Facility: Power Plant

Address: 1501 Business Loop 70 East

Date of Survey: 07/01/11

Photo 4

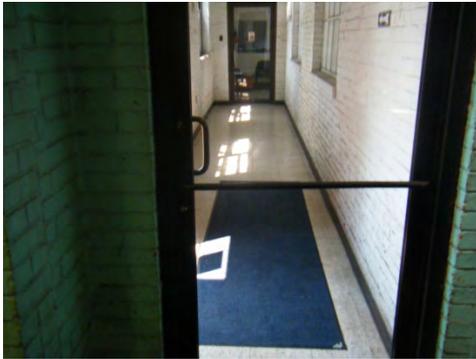
- Door out of the Power Plant and into the Corridor leading to the Offices (see photo 4 next page) only has 14” latch side clearance on the corridor side of the door. Install a door hold-open device so that the door can be held open during

public meetings and/or when a wheelchair user is visiting the facility. Additionally, adjust the door closer at this door to operate with 5 lbs. force or less and replace the existing non-compliant threshold with one that meets ADAAG 4.13.8. **Estimated Cost: \$381.00**

Photo 5

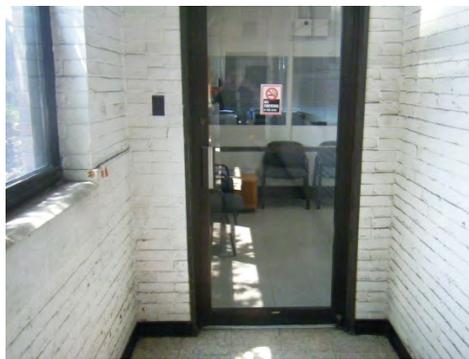
- Door from the Corridor leading into the Offices (see photo 5 below) only has 15.5" latch side clearance on the corridor side of the door. Install a door hold-open device so that the door can be held open during public meetings and/or when a wheelchair user is visiting the facility. Additionally, adjust the door closer at this door to operate with 5 lbs. force or less.

Figure 69.35-1/Toilet Room

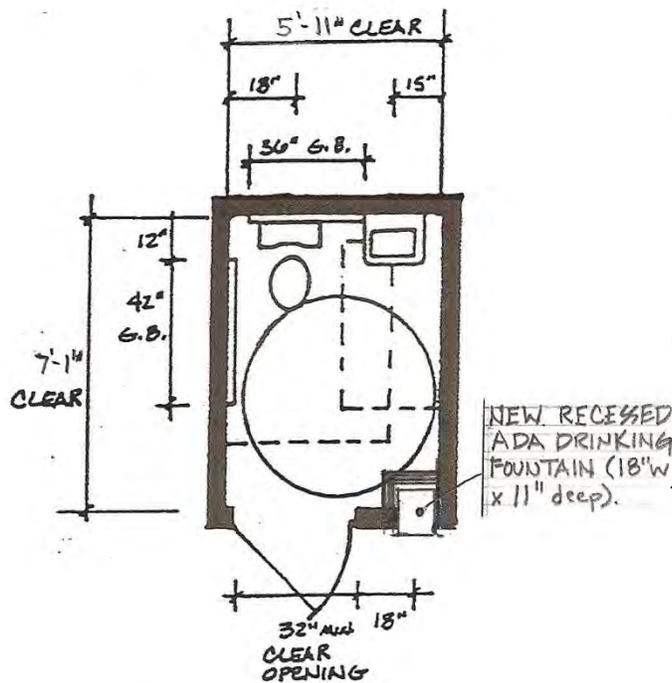
- The existing ADA Restroom in the power plant (see photo 8 below) is a Women's Restroom and does not meet ADAAG guidelines for accessibility. Recommend reconfiguring the current restroom as shown in the sketch below so that the restroom becomes a Unisex Accessible Restroom. The modifications will include moving the entry door to the east side of the existing restroom, installation of the recessed ADA drinking fountain (cost and details included in Section 3.1 above), replacement of the existing lavatory and base cabinets with an ADA compliant wall-hung lavatory, adjusting location of toilet fixture and grab bars, installation of door lever with privacy lock, lowering the mirror and dispensers, installing ADA signage and insulating the lavatory pipes.
